Notes:	Rev	By	Date	Description	AS1657	TEK1 PTY LTD			
	A		//	ISSUED FOR APPROVAL					
					www.tek1.com.au	Drawn By:	TEK1		
						Checked By:			
						Approved By:			
					Scale:	Project No:	Drawing No:	Size:	Rev
					1:50		info@tek1.com.au	A3	A

**A - A**

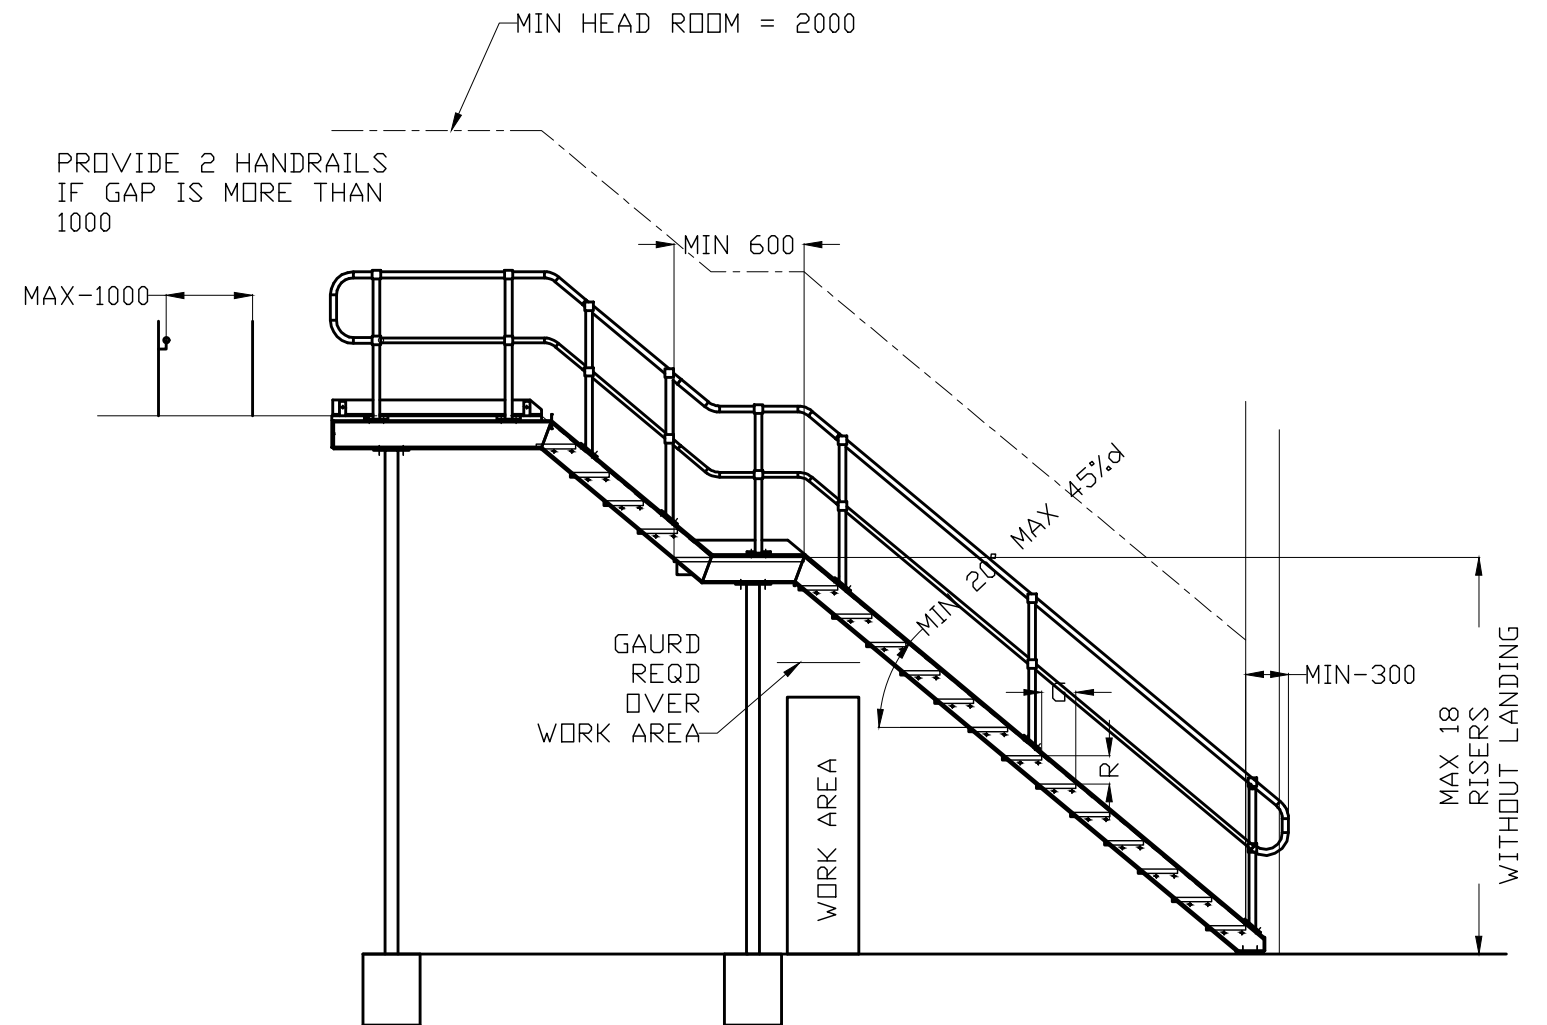
VALID BECAUSE DIFFERENCE IS WITHIN 5 MM

G- MIN = 215 - MAX = 355  
 R- MIN = 130 - MAX = 225  
 ALSO  
 $540 \leq (2R+G) \leq 700$   
 R AND G SHOULD BE UNIFORM WITHIN 5 MM TOLERANCE
